Our Ref: KC2225/MS

**Proposed Development of Curraghinalt Mine
Response to NIEA letter of 20th December 2021; Ref: AIL/2020/0105, AIL/2020/0106**

- AIL/2020/0105: Surface Water Abstraction Licence Application
- AIL/2020/0106: Groundwater Abstraction Licence Application

Figure 1: Inflows to Underground Mine from abstraction licence application and July 2020 water balance – groundwater model predictions, with highest total (used in abstraction licence application) highlighted by red circle

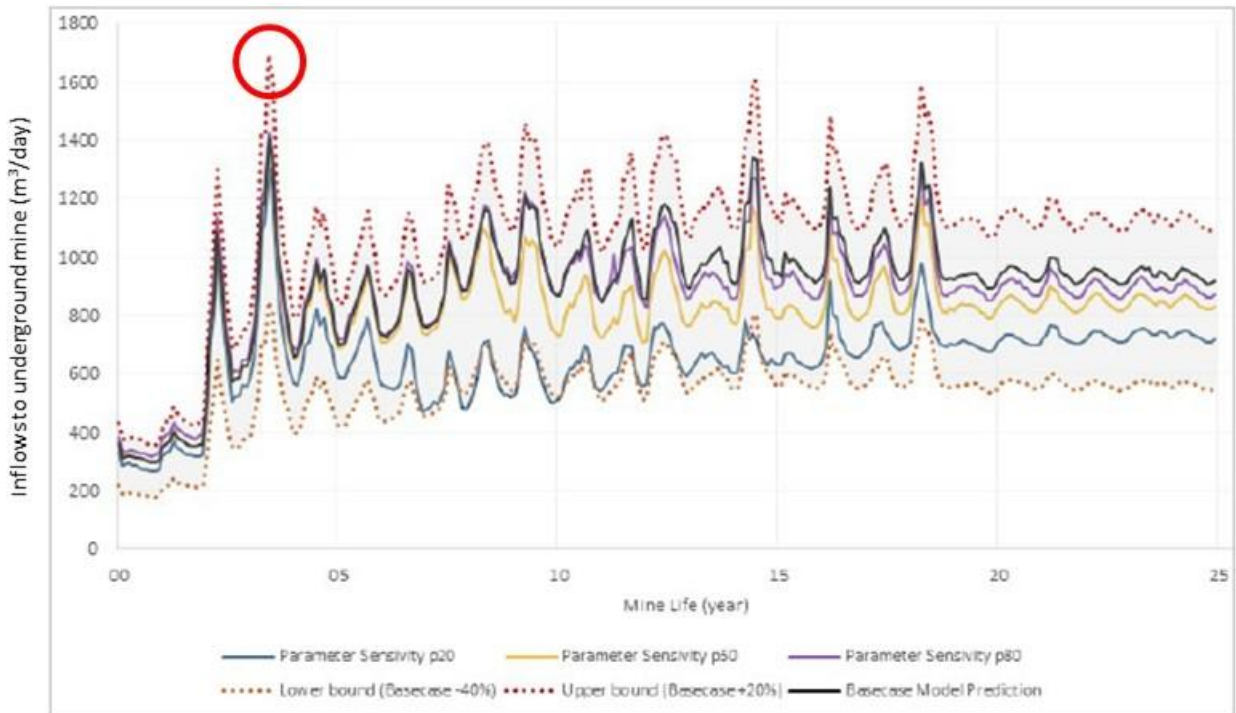
- 1. Please confirm the actual volumes proposed for abstraction for both applications AI/2020/0105 and AIL/2020/016. Please provide a detailed schematic drawing of the full proposal setting out clearly the volumes for abstraction, storage volumes and finally discharge. NIEA recognise that these details may have been submitted previously however a range of figures have been provided, as such the information provided in response to this information request will be considered the final volumes proposed for abstraction.**

Abstractions will vary month by month depending on the stage of the mine life and the rock type. The abstraction figure of 1,700 m³/day used in the application refers to the maximum value predicted from groundwater modelling of water flowing into the underground mine. The Environmental Impact Assessment (EIA) for the project included groundwater modelling which considered a range of climatic conditions and other model parameters, producing a range of predictions for water entering the mine workings. The range of values are summarized in Figure 1, which was provided within the Abstraction Licence application documents.

Figure 1 illustrates how mine water inflows and abstractions would vary through the life of mine. The value in the abstraction licence application is illustrated in Figure 1 with a red circle. The value in the abstraction licence is the maximum predicted volume of 1,700 m³/day (70.8 m³/hour or 19.7 L/s). Within the October 2020 Water Balance Report the groundwater modelling was updated. Following this update the maximum discharge reduced to 1,610 m³/day. We are content to retain the maximum discharge rate of 1,700 m³/day, as per the application, given the small difference (5%) in values.
